Medway Design Review Committee Meeting
Monday, February 06, 2023
Zoom (Remote) Meeting

Project Review – 7 Sanford Street Multi-Family Special Permit Application

Medway Commons Site Plan – Chipotle and Starbucks, 67B and 67C Main Street

Milford Regional Hospital Medical Facility Master Signage Plan – 86 Holliston Street-

④ Proposed West
1/8" = 1'-0"

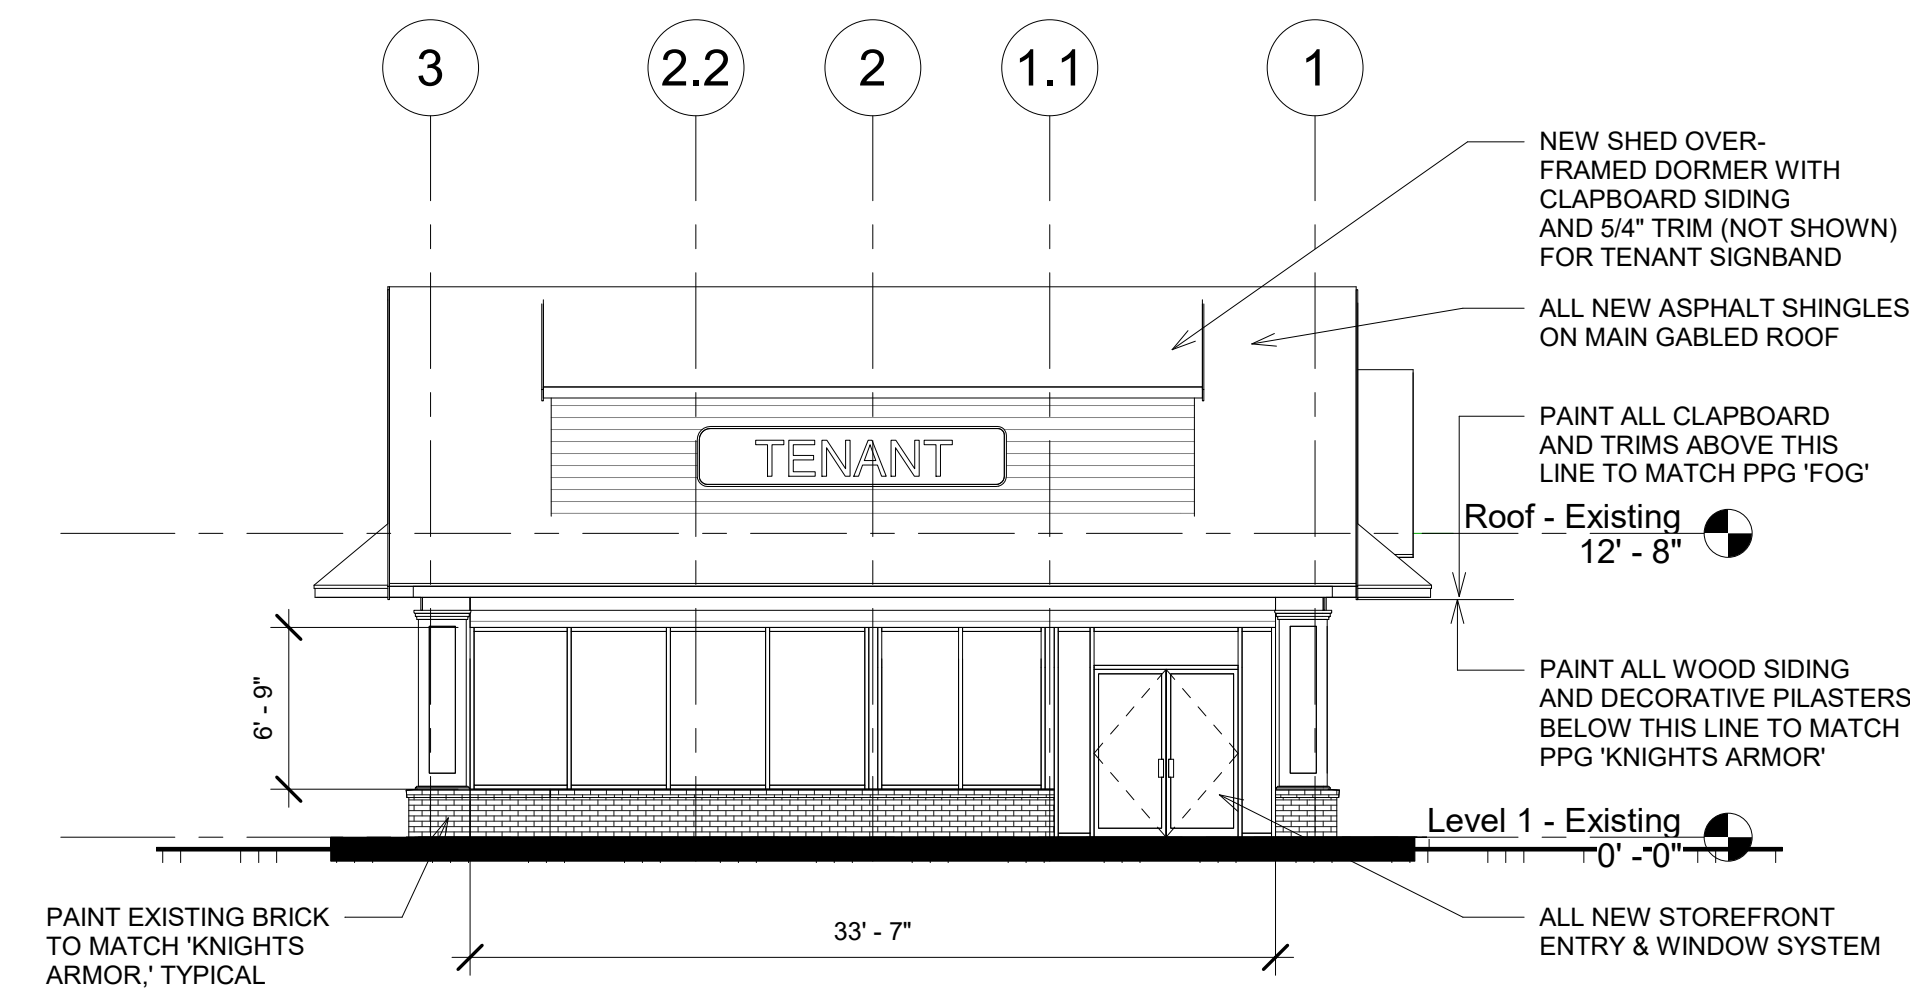
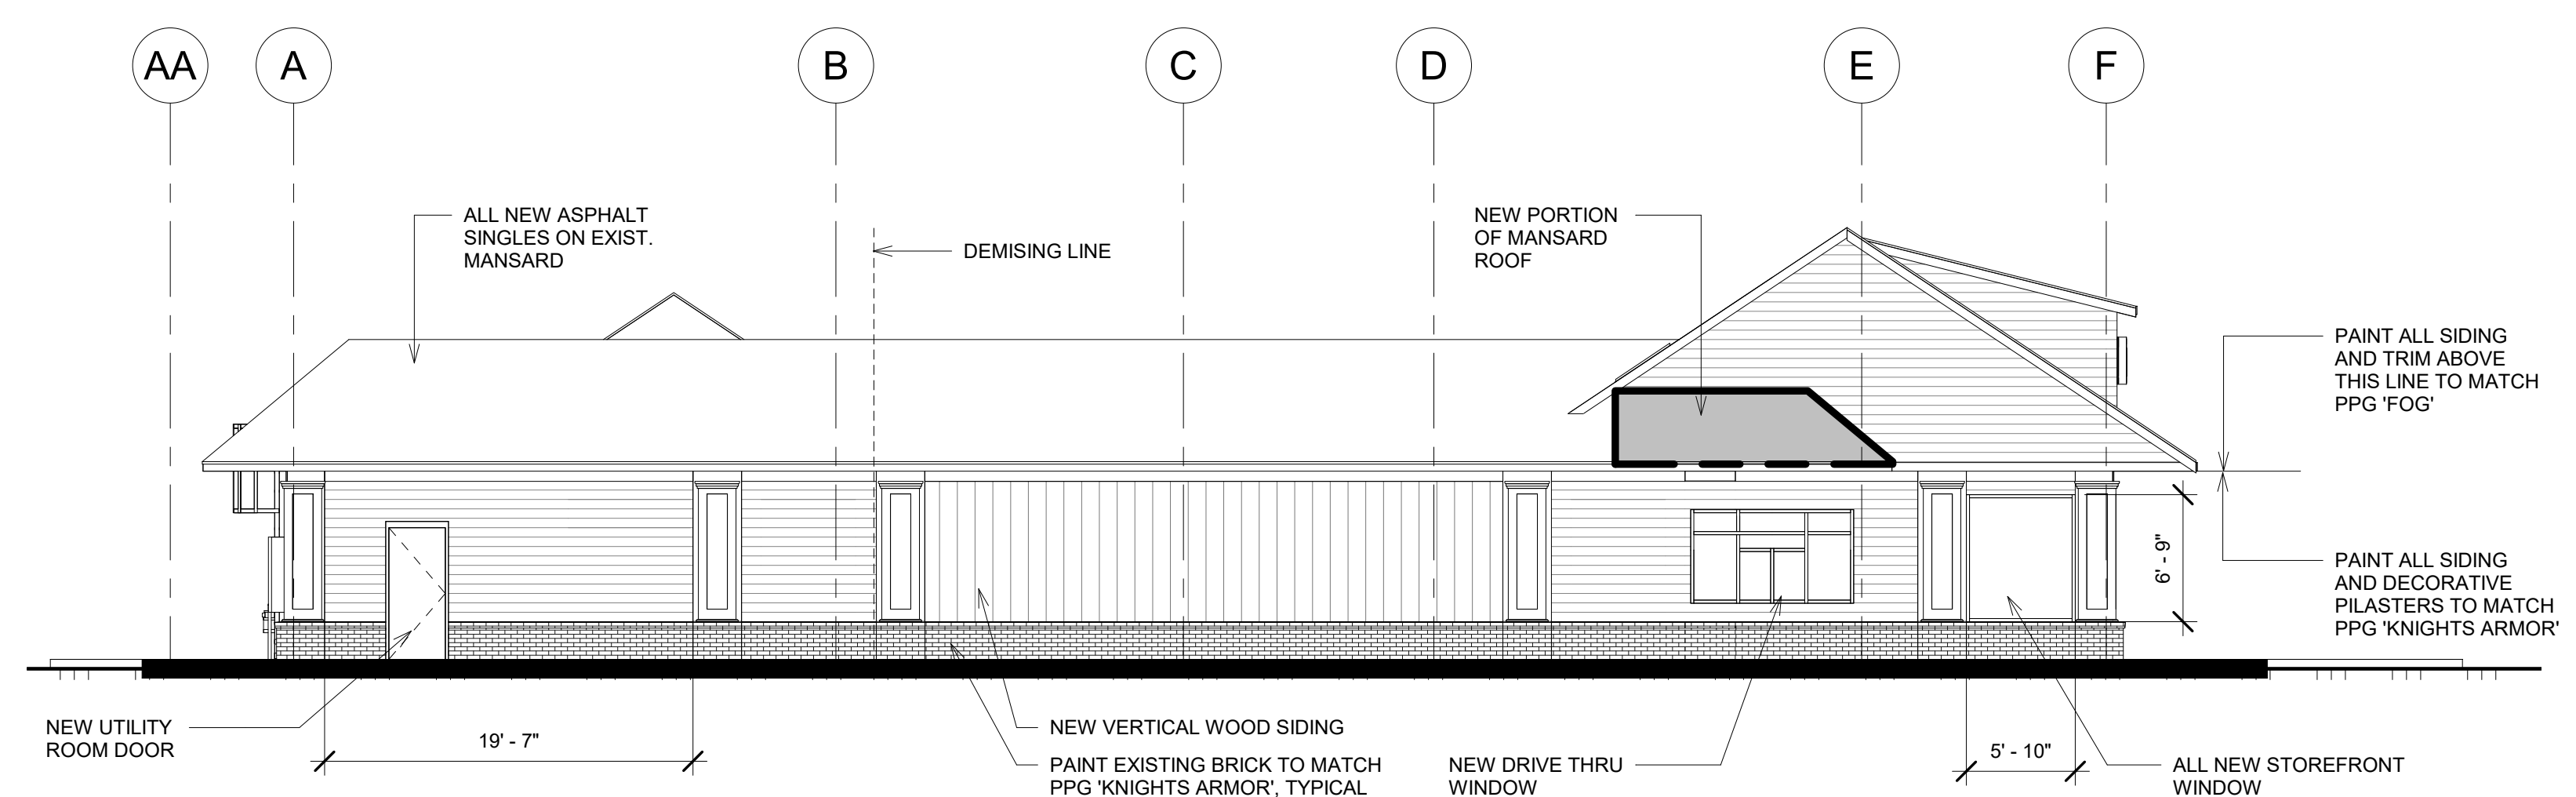
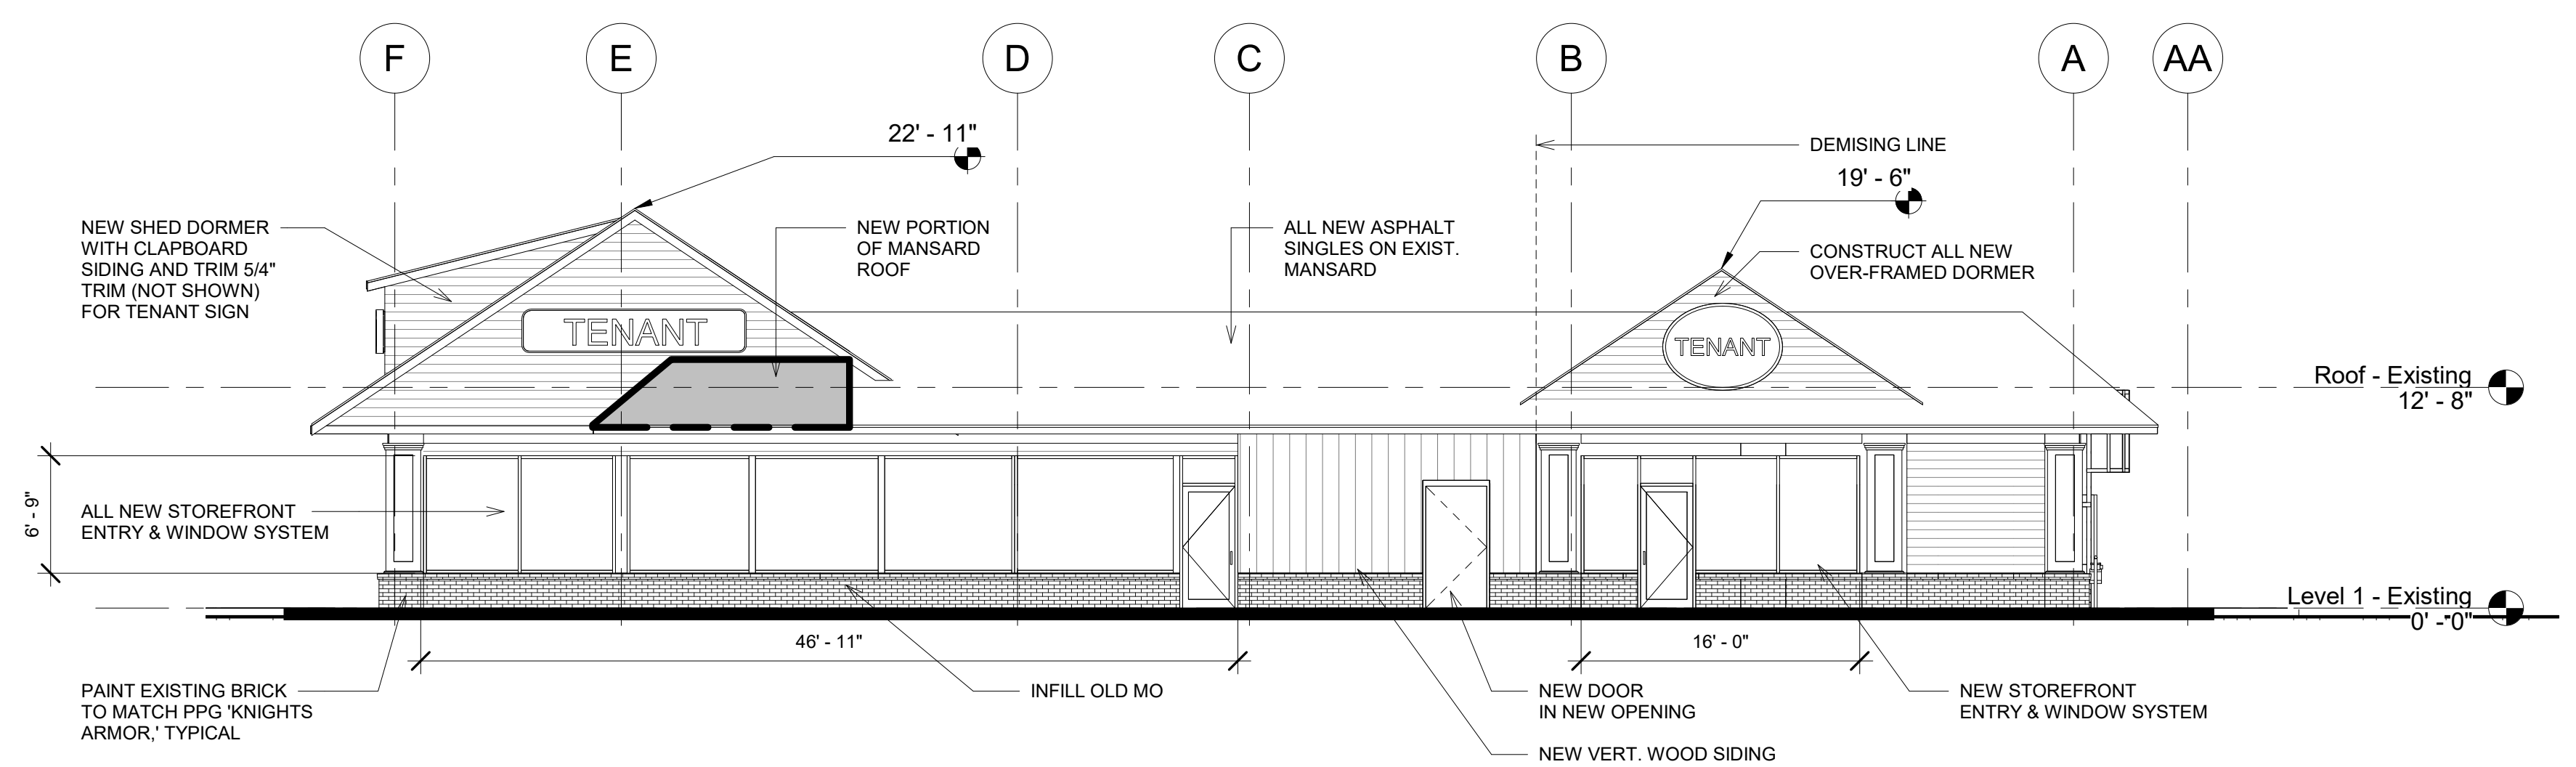
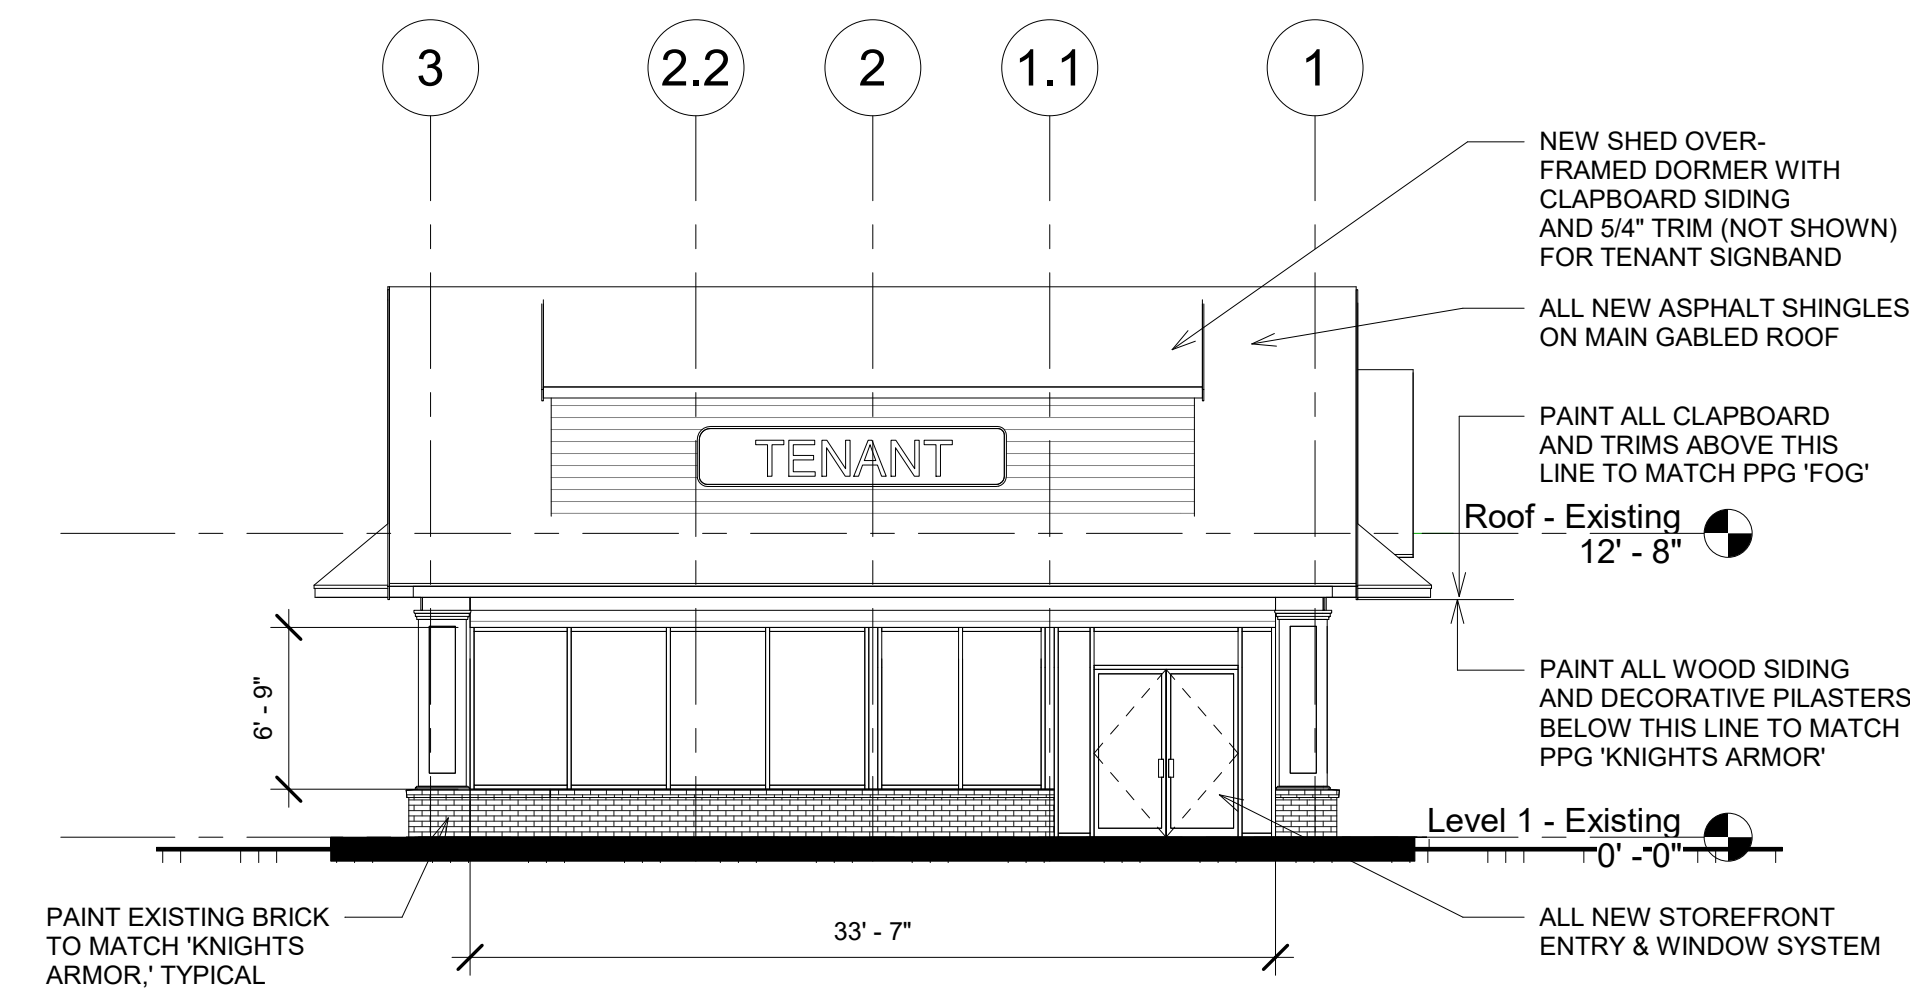
Proposed street views were shown and discussed with the members. Mr. Buckley asked about the roof ladder on the west elevation. It was mentioned that it's a necessity to provide safe and OSHA compliant access to the roof. The frequency of the access will be regular between the tenant and owner's needs for maintaining the building's HVAC systems including the roof. There was discussion on making some visual and design improvements to prevent the split in the mansard. A

screen/ panel like structure on top of the ladder was suggested to fill the gap between mansards. Ms. Johnson reminded that safety should not be compromised which could potentially occur with the presence of a screen at that location.
